## **Regional Municipality of Durham**

### **Bid Opportunity: T-1160-2021 – Construction of New Seaton Paramedic Station and Training Facility in the City of Pickering**

#### **Addendum Number 03 – December 17, 2021**

### FOUNDATION PLAN

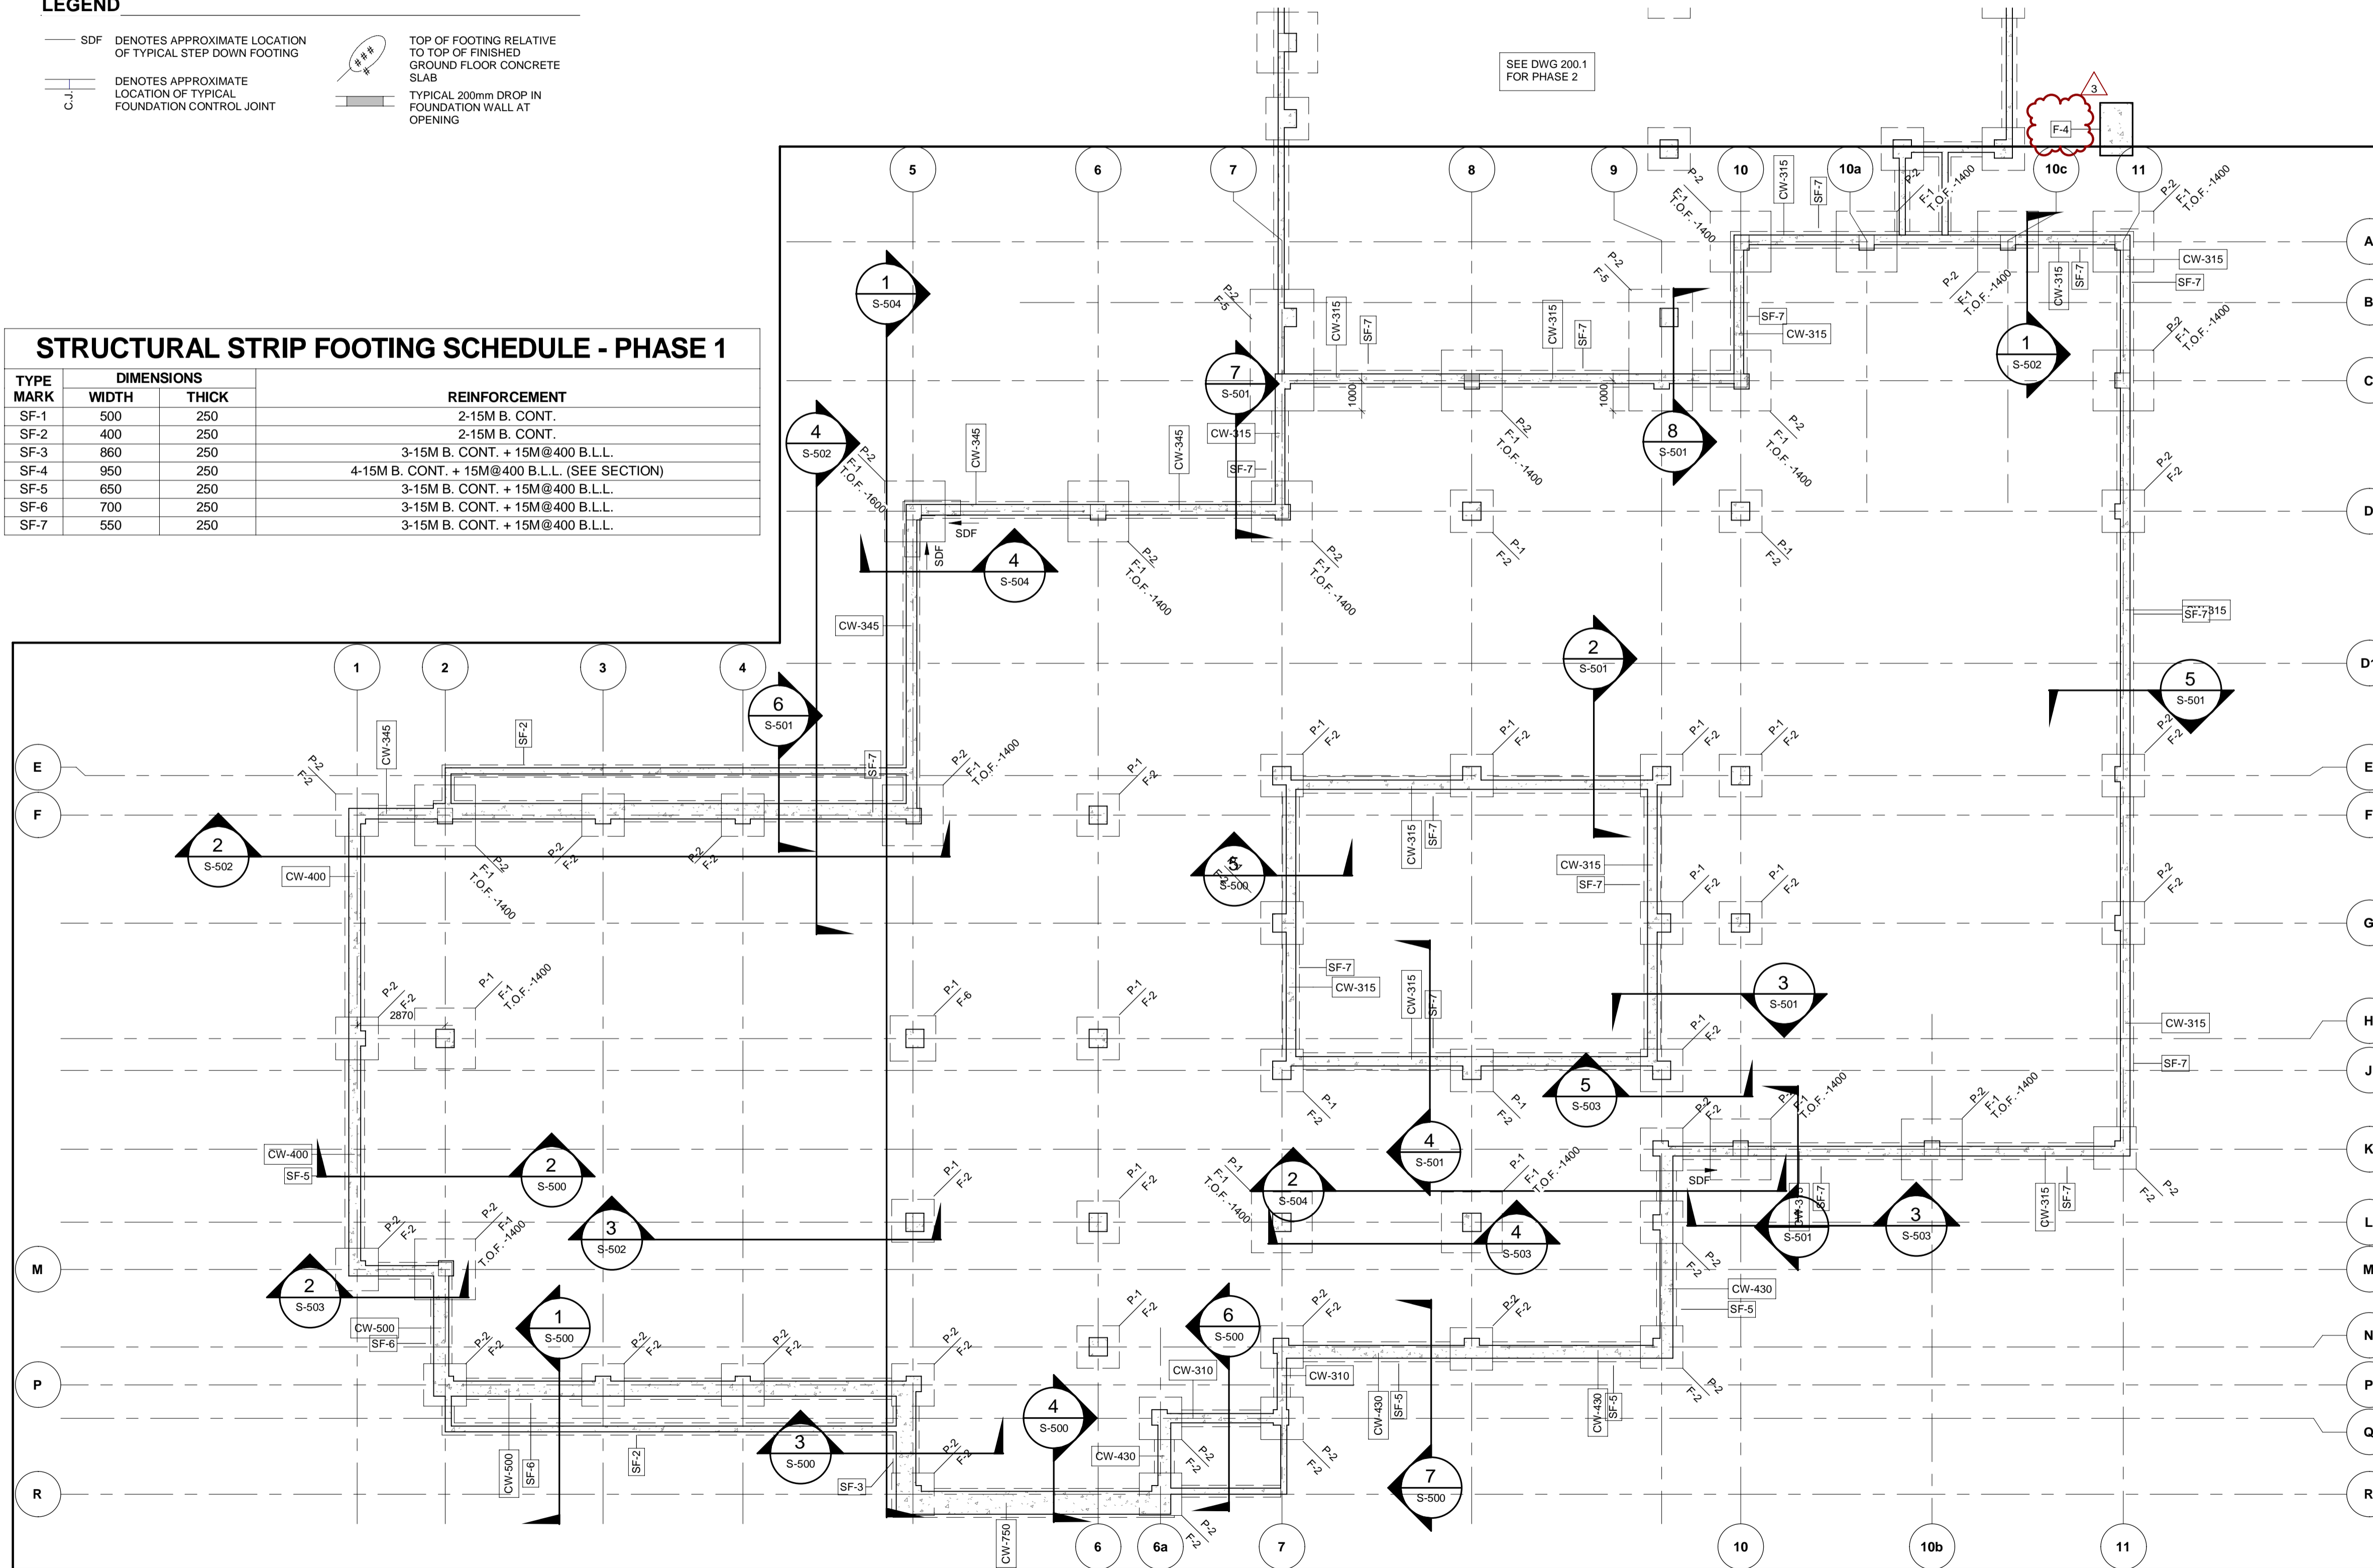
Referencing to spread footing schedule in structural drawing S-200, no reinforcement information has been provided for type F-1 and F-4. Please clarify.

F-1 reinforcement information has been added to revised drawing S-200, issued with this Addendum 03.

For F-4, please include reinforcement for 2% of the cross-sectional area in the bid amount.
